Project: Ketchikan Shipyard Medium Voltage
Loop

Solicitation No.: 19014

Addendum No. One

KETCHIKAN SHIPYARD MEDIUM VOLTAGE LOOP
 3801 N. TONGASS AVENUE
ELECTRICAL ONE-LINE DIAGRAM - BASE BID

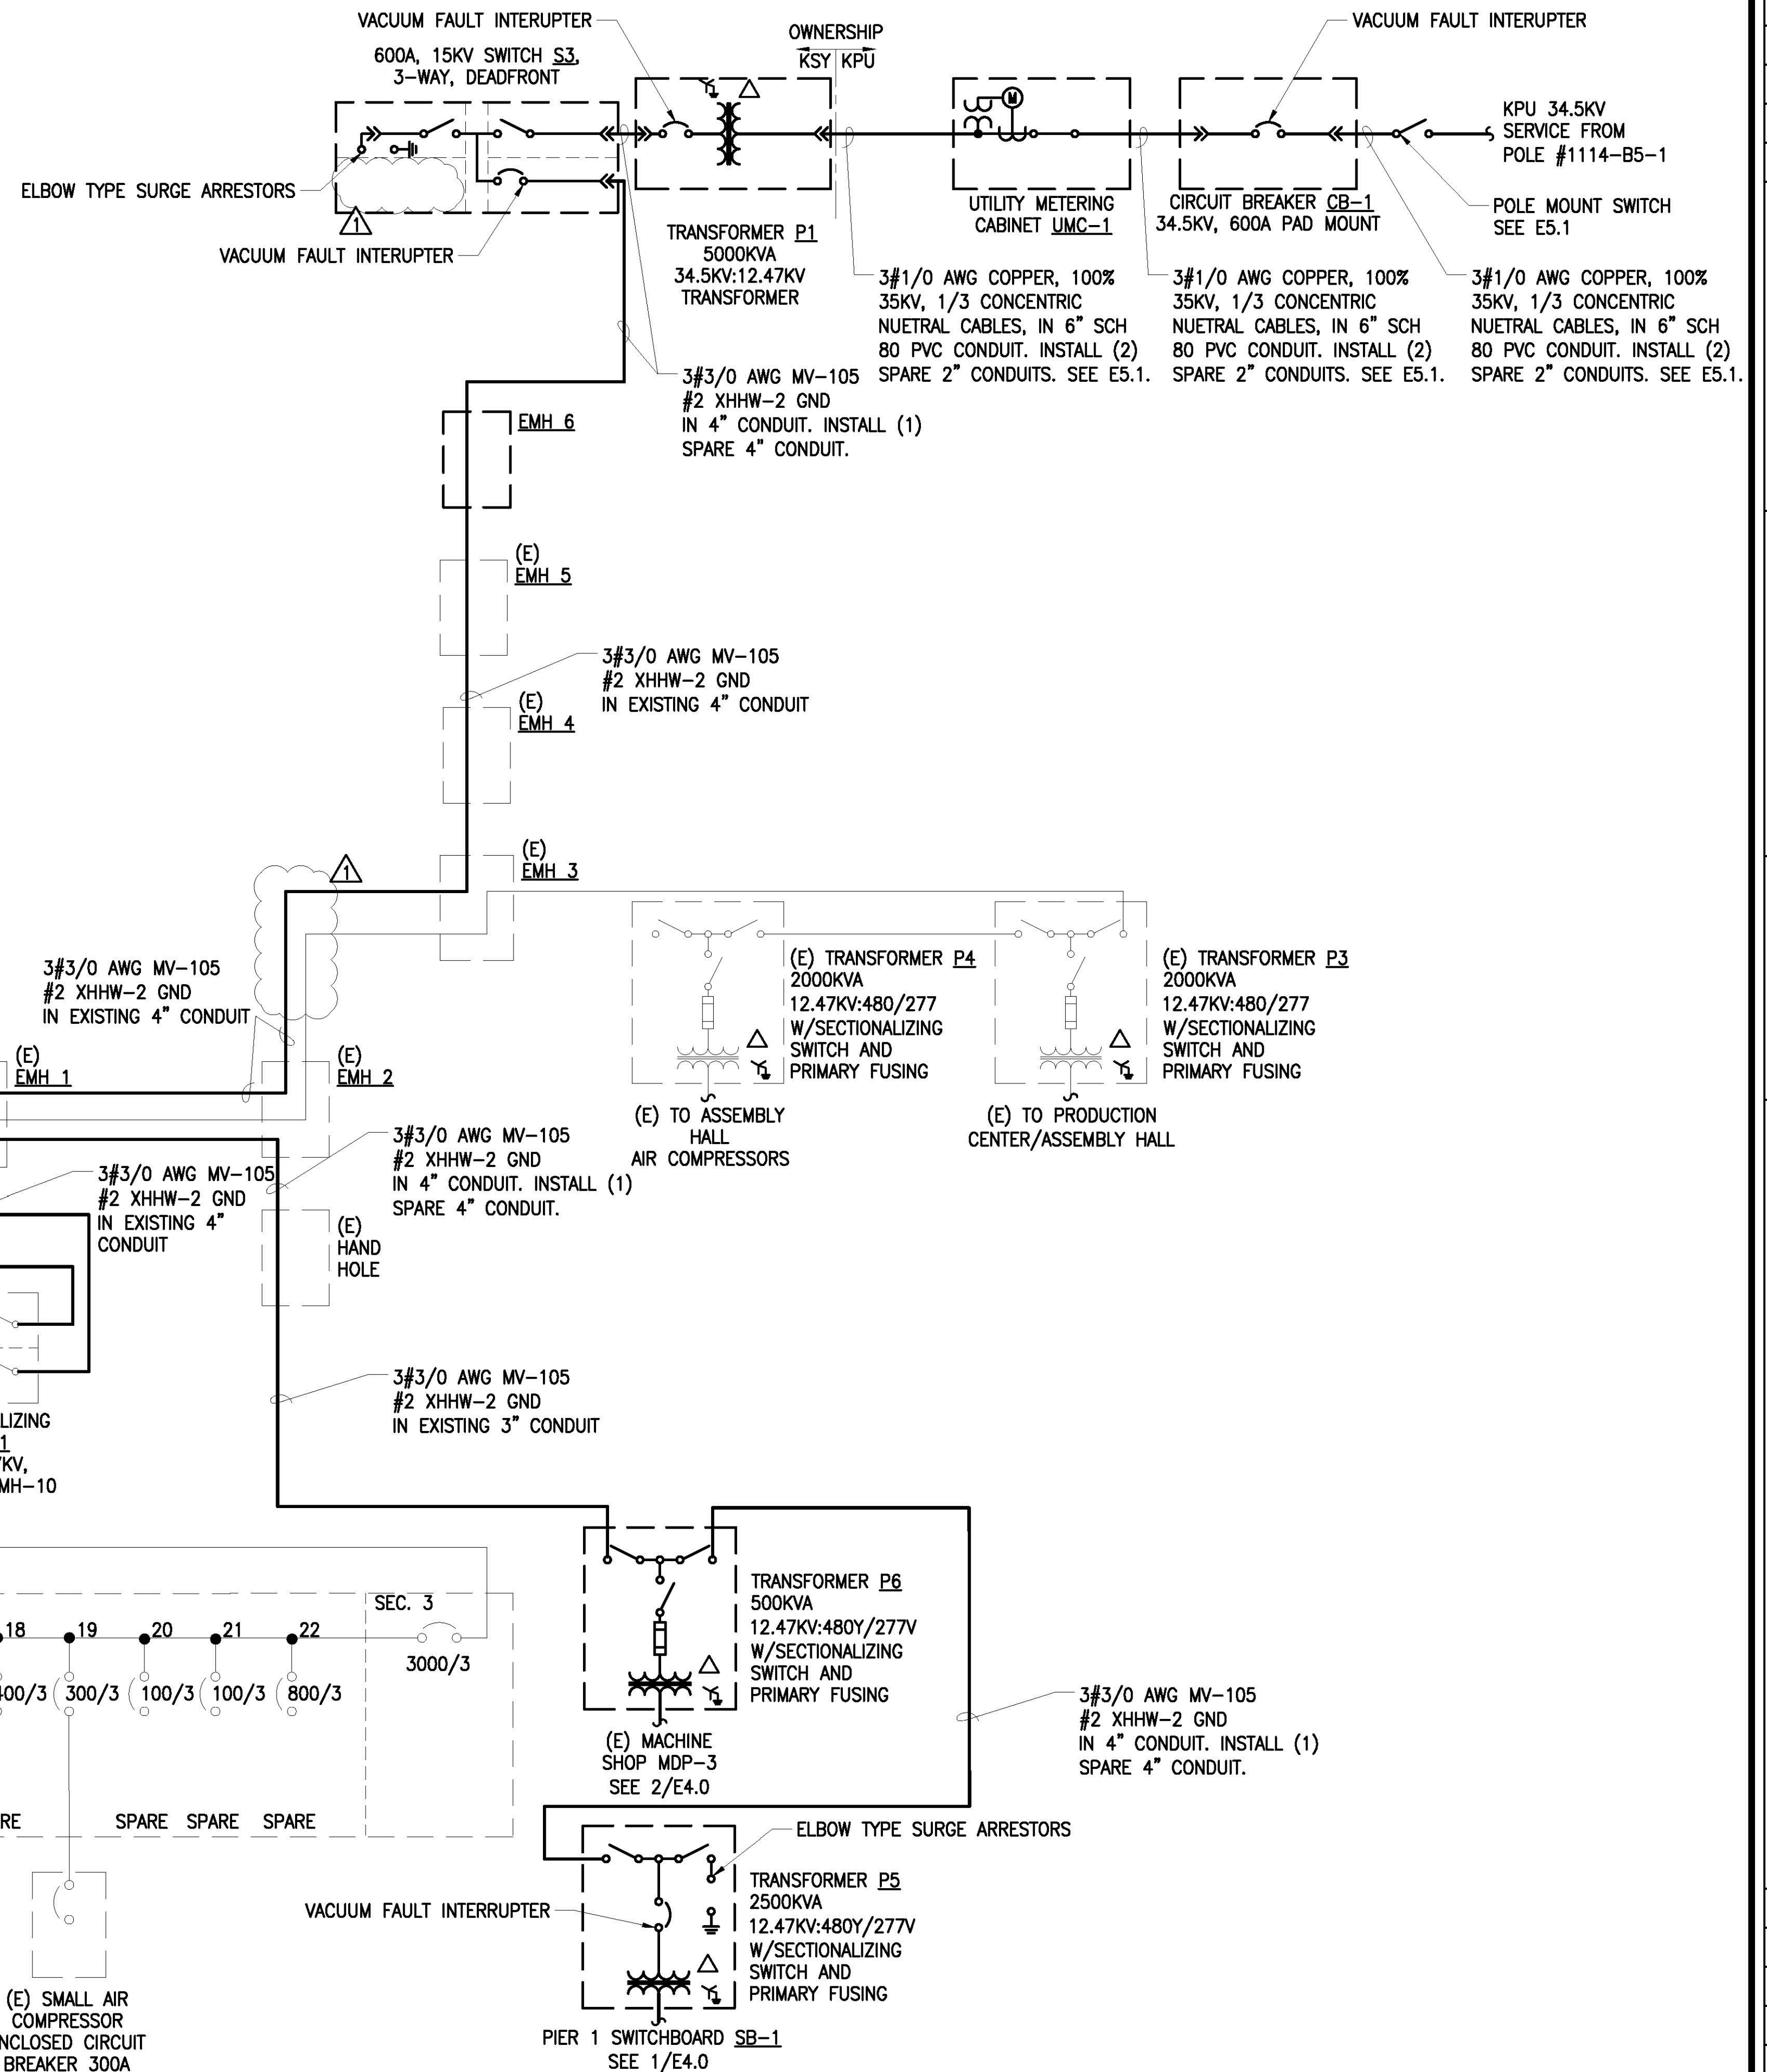
- 9) **Q:** 26 05 13 Specification vs Sheet E3.0 - Is 100% or 133% insulation required on 35 kV cables?
A: 100%.

- 13) **Q:** Confirm that note #10 on sheet E0.0 applies to both low and medium voltage conduit.
A: Confirmed.
- 14) **Q:** E3.0 Are switches S-3 and S-4 three-way or four-way?
A: Three-way, minimum. Four-way is also acceptable.
